Figure 19 WIRING SIDE BOARD (P.W.B. NO. F0485AF-3)

Figure 18 SCHEMATIC DIAGRAM (P.W.B. NO. F0485AF-3)

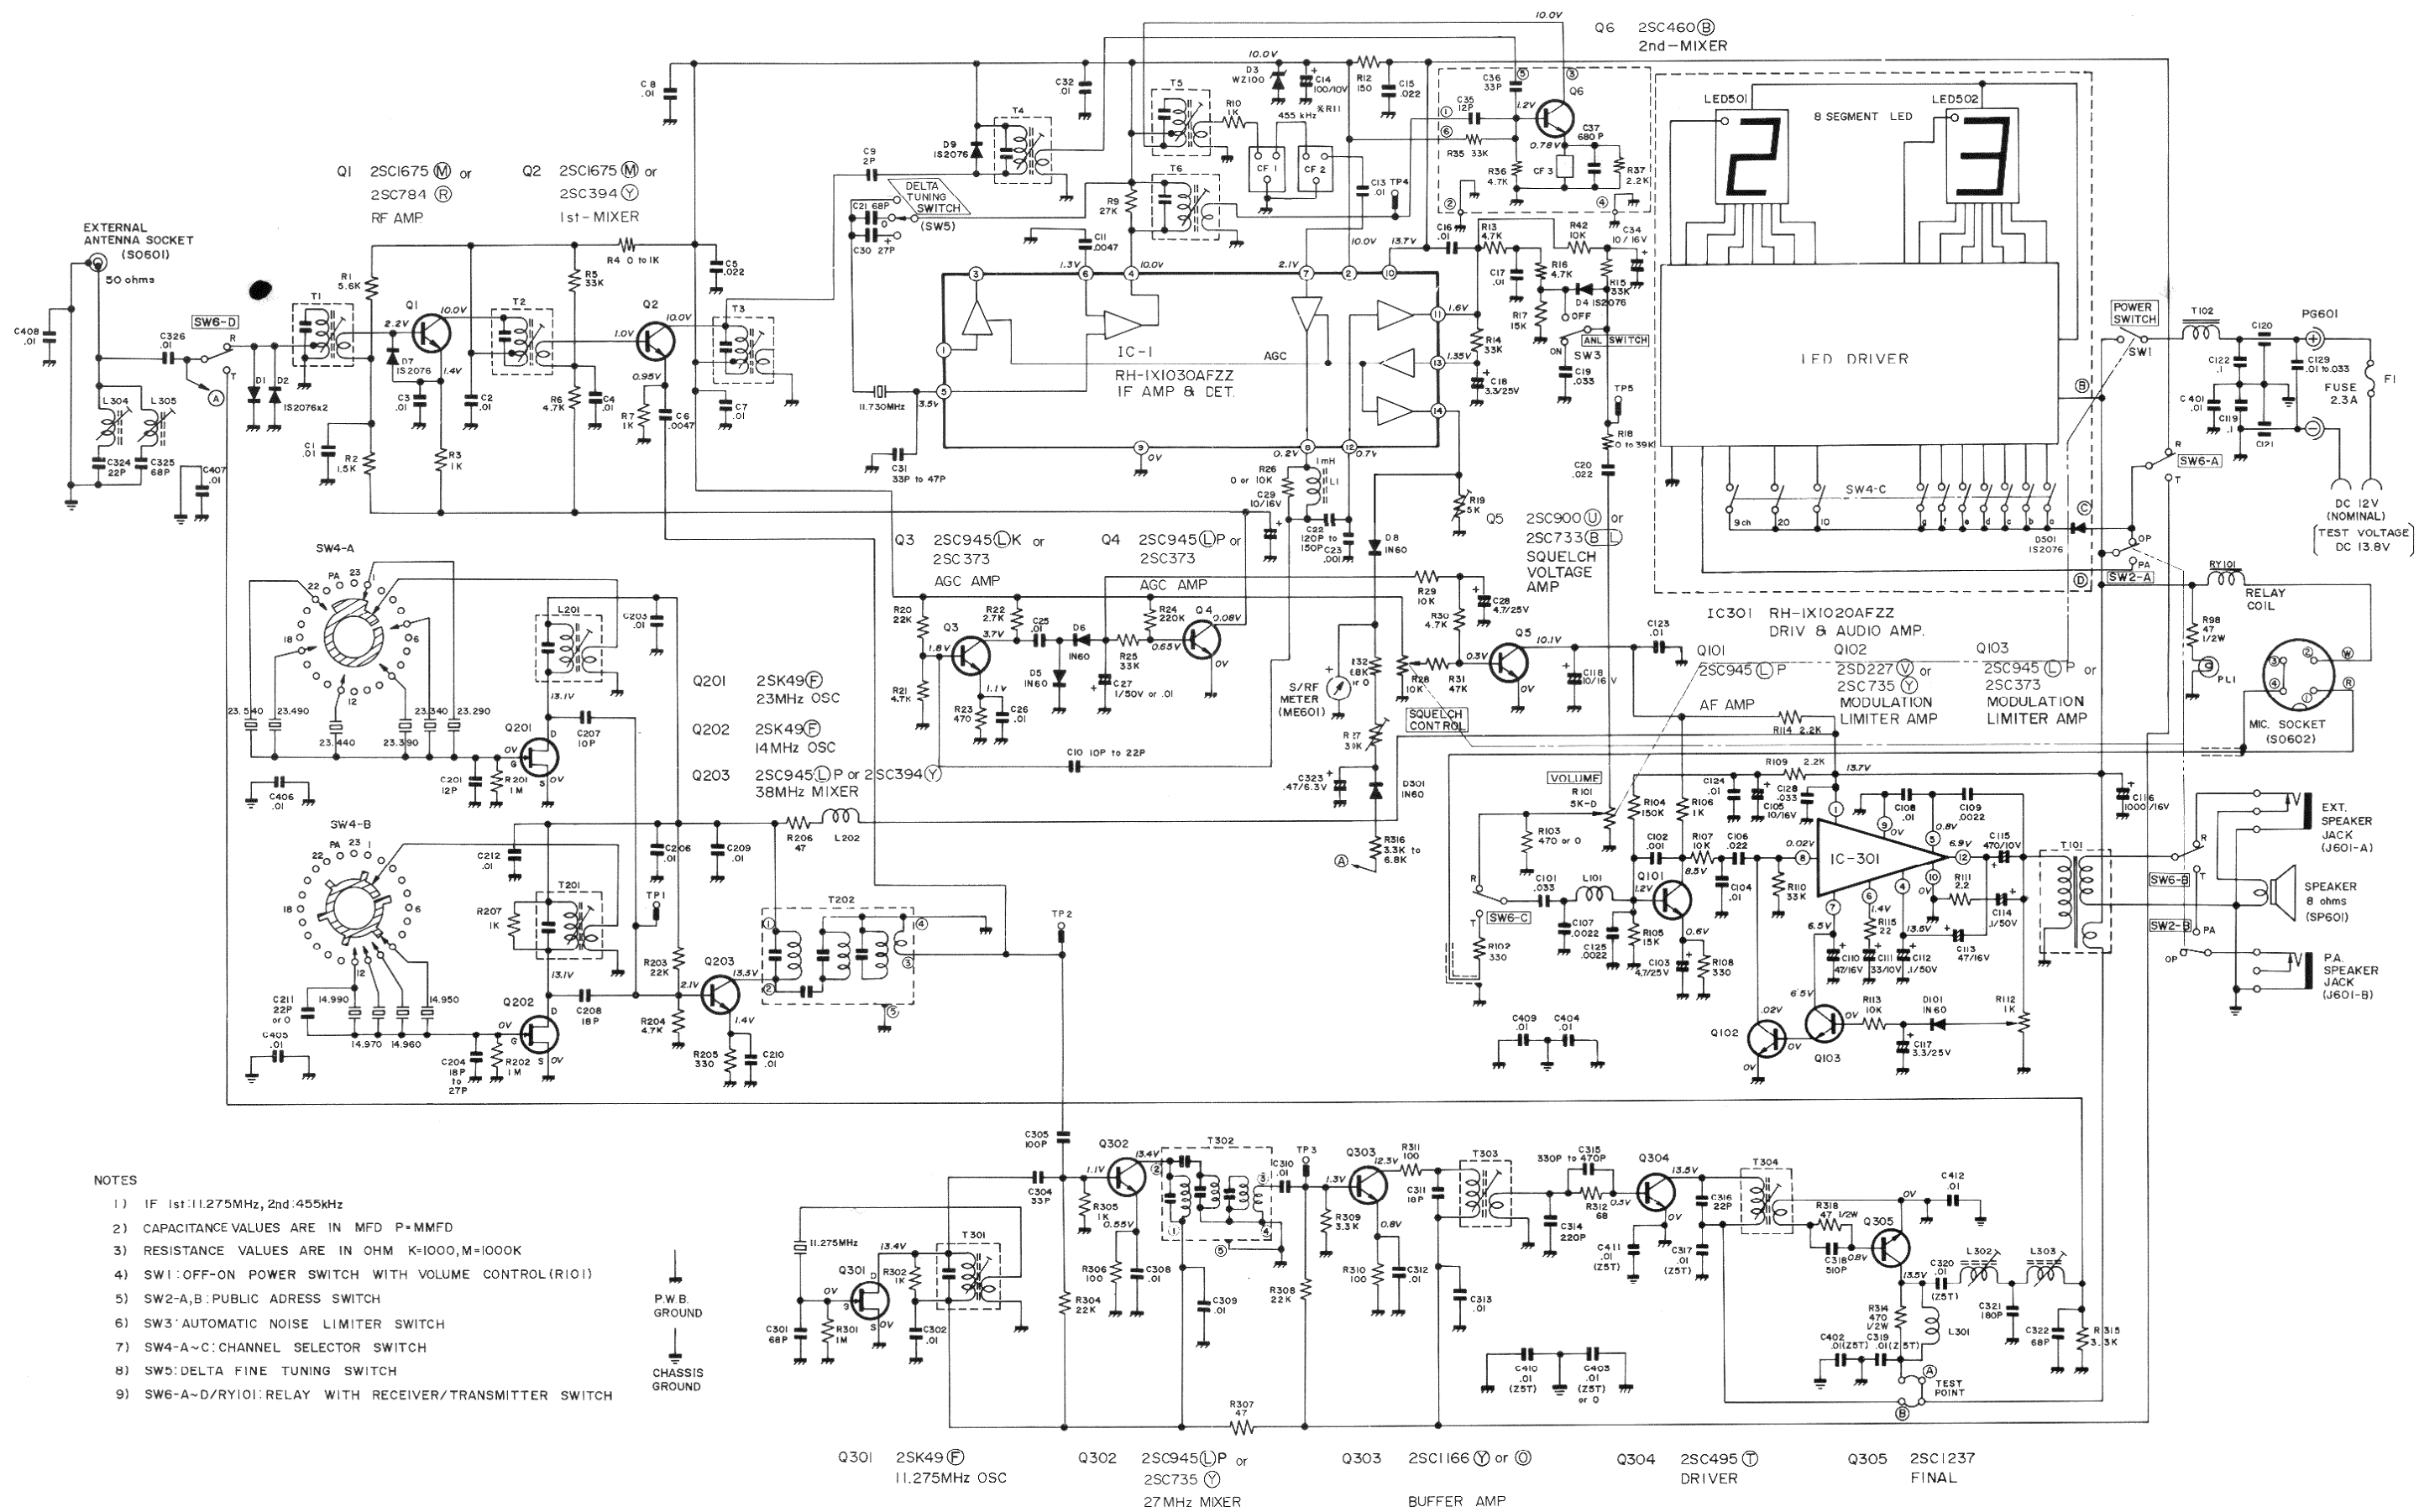
- In case of adding ceramic filter CF-2 and CF-3. (Reference figures are 18 and 19.)
 - Add a ceramic filter CF-2 (RFILA0050AFZZ)
 - Add a ceramic filter CF-3 (RFILA0001AFZZ)
 - Change the capacitor C37 from 0.01MFD to 680PF (VCCSPU1HL681J)
 - Cut the printed circuit pattern, the place is shown on Figure 19-①.
- In case of adding ceramic filter CF-3. (Reference figures are 18 and 19)
 - Add a ceramic filter CF-3 (RFILA0001AFZZ)
 - Change the capacitor C37 from 0.01MFD to 680PF (VCCSPU1HL681J)

Figure 21 WIRING SIDE BOARD (P.W.B. NO. F0485AF-4)

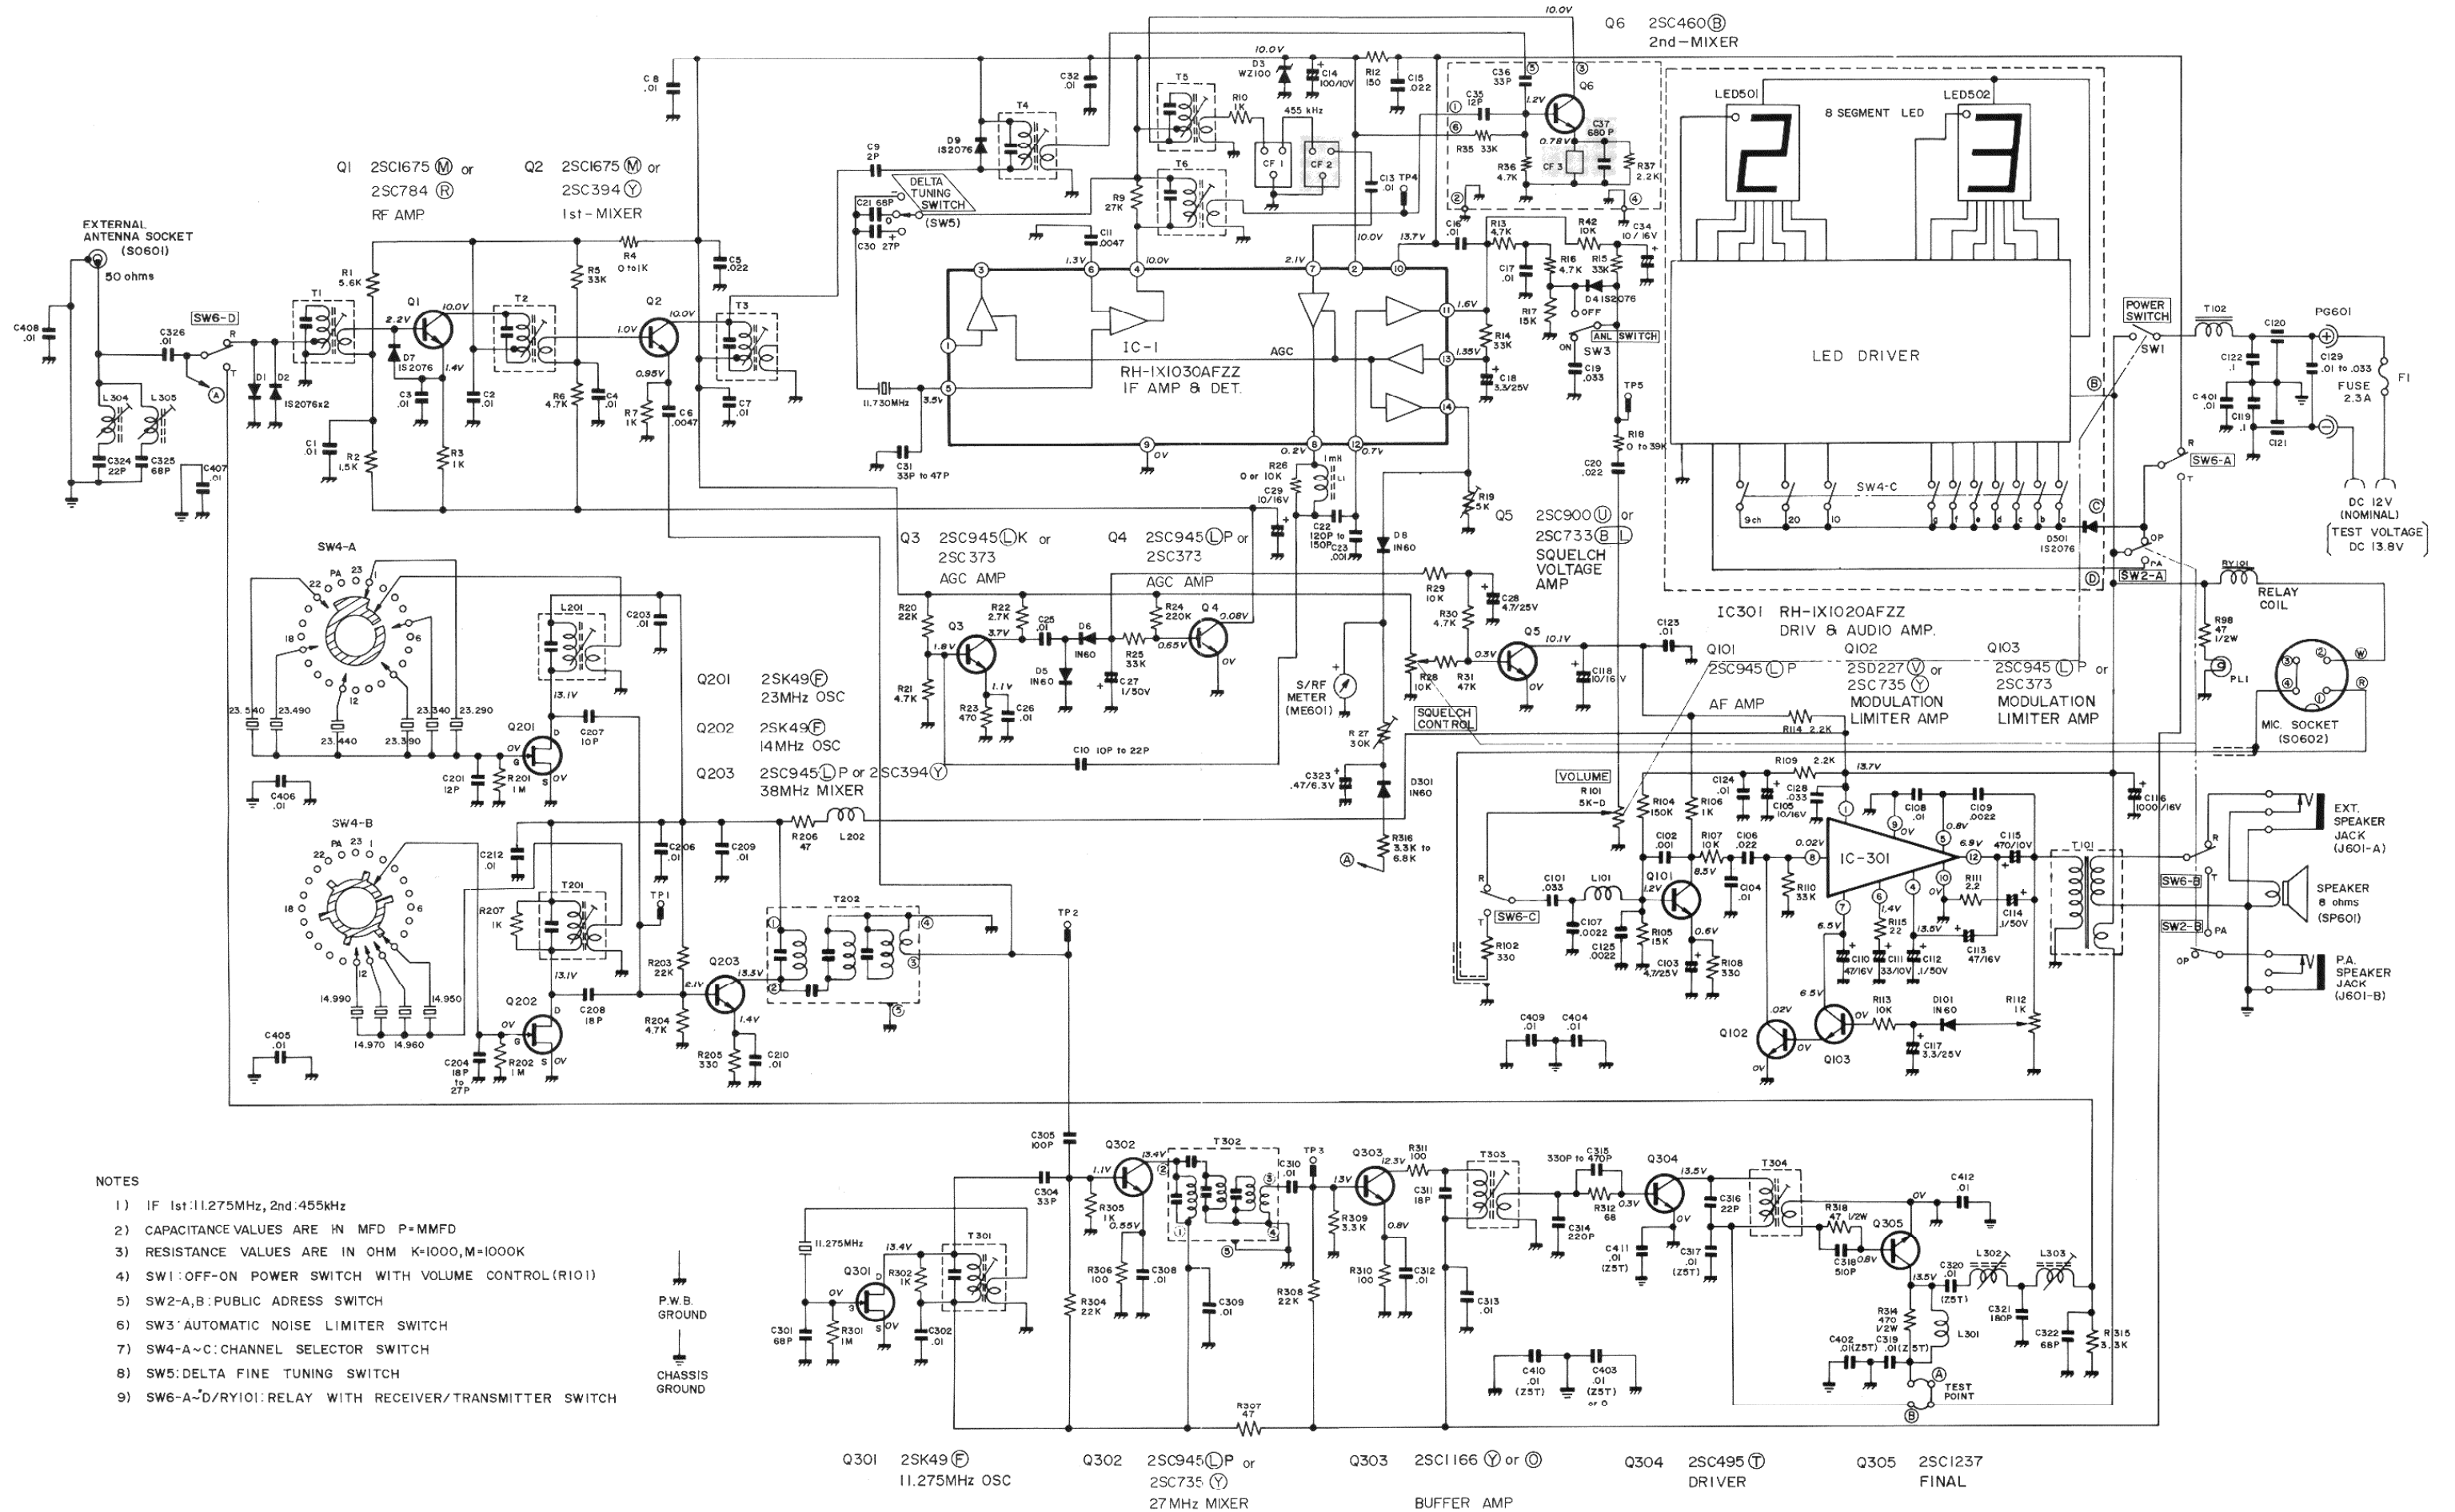
- NOTE:
- 1) In case of adding ceramic filter CF-2 and CF-3.
(Reference figures are 20 and 21.)
 - ① Add a ceramic filter CF-2 (RFILA0050AFZZ)
 - ② Add a ceramic filter CF-3 (RFILA0001AFZZ)
 - ③ Change the capacitor C37 from 0.01MFD to 680PF (VCCSPU1HL681J)
 - ④ Cut the printed circuit pattern, the place is shown on Figure 21-①.
 - 2) In case of adding ceramic filter CF-3.
(Reference figures are 20 and 21)
 - ① Add a ceramic filter CF-3 (RFILA0001AFZZ)
 - ② Change the capacitor C37 from 0.01MFD to 680PF (VCCSPU1HL681J)
